SHAGBARK LUMBER AND

PETITION NO. 1215

ANSWER TO THE SITING COUNCIL

INTERROGATORIES SET ONE

RESPONSE TO NOS. 19 and 25

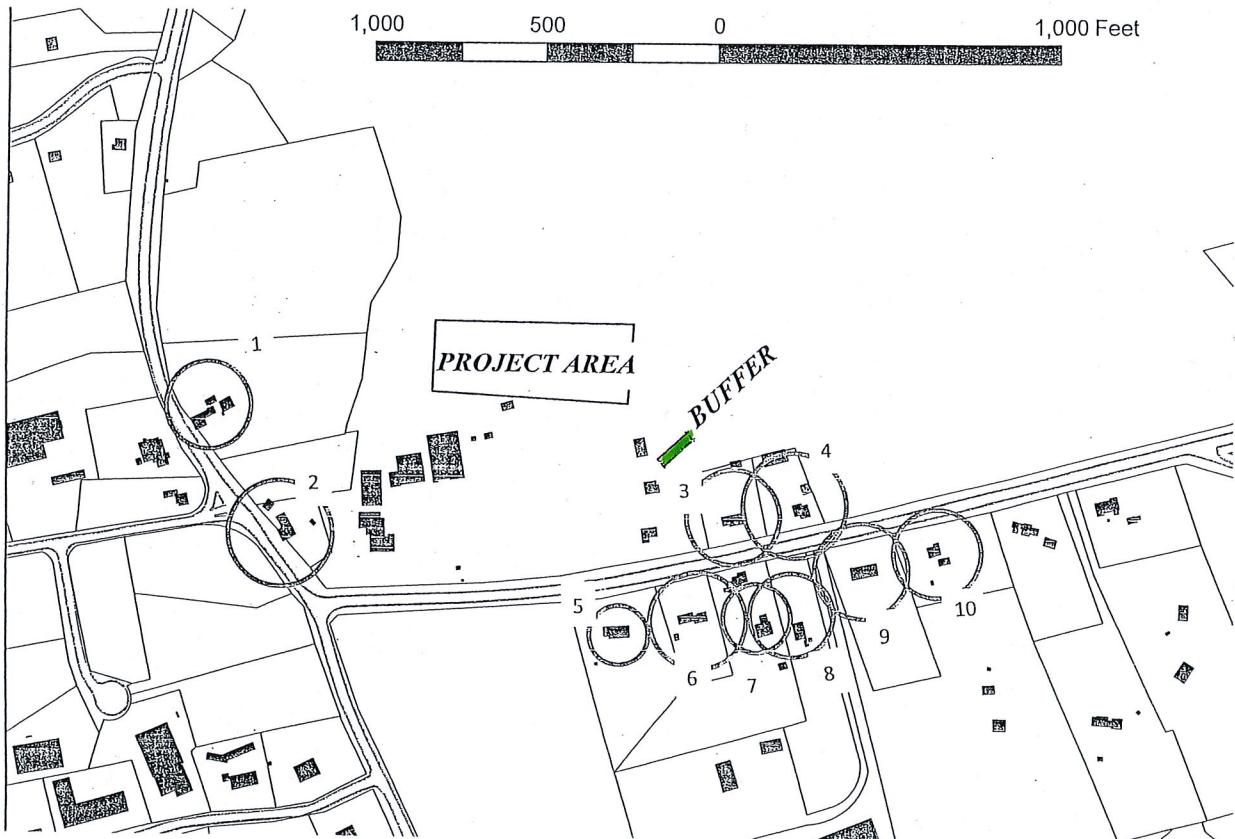
25. The map below illustrates project area and approximate location of proposed buffering, just east of the southeast corner of the livestock barn. Exact landscaping will be determined in the field upon completion of installation.

SITE PLAN - PROPOSED SOLAR GENERATION FACILITY

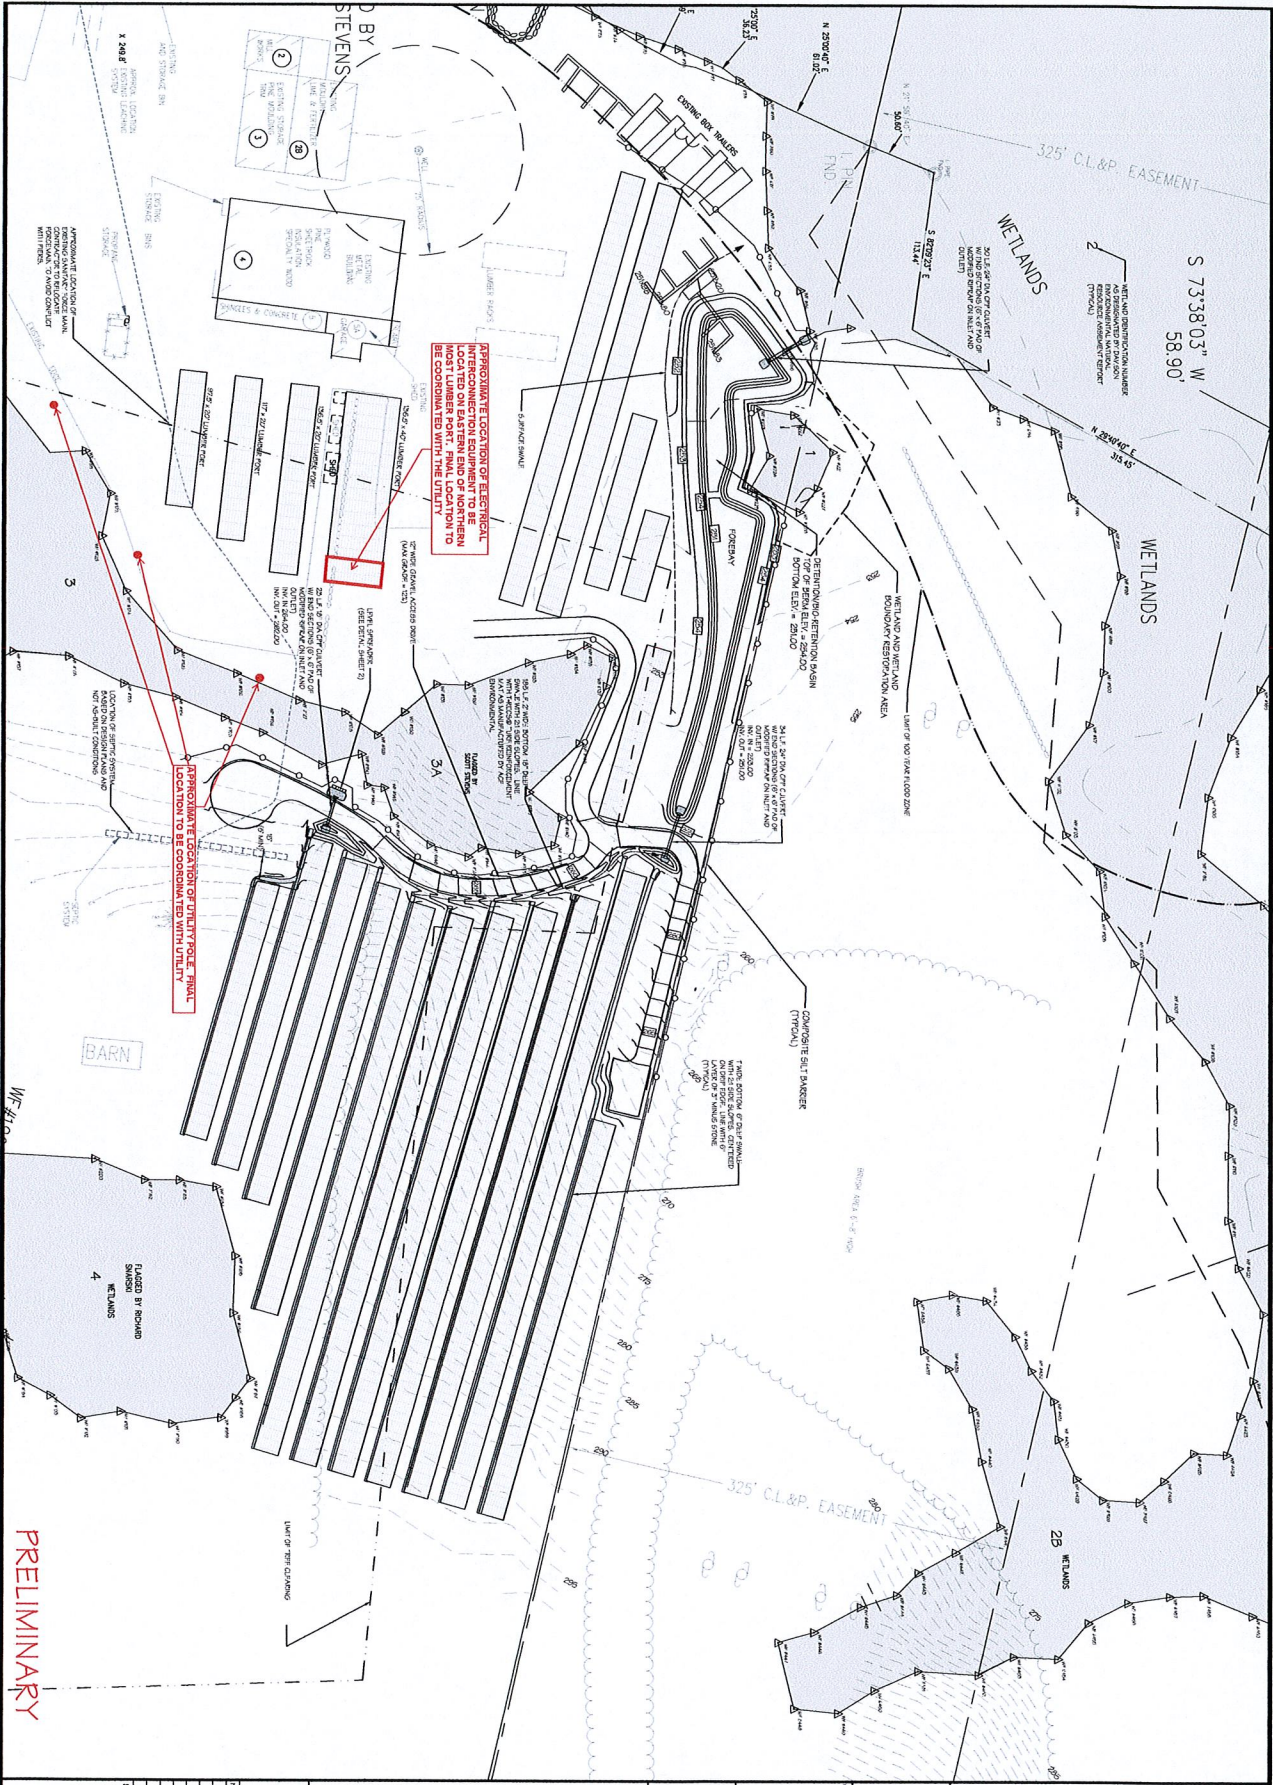
- 15. The project is designed to use a common 2 inch chain link fence without barbed wire.
- 16. Please see attached site plan. The approximate locations of the new utility poles and electrical equipment are identified. The final location is to be coordinated with the utility.
- 17. The ground mounted solar panels will have a 2 foot clearance at the leading edge (southern side). The car port solar arrays will have a 12 foot clearance at the leading edge.
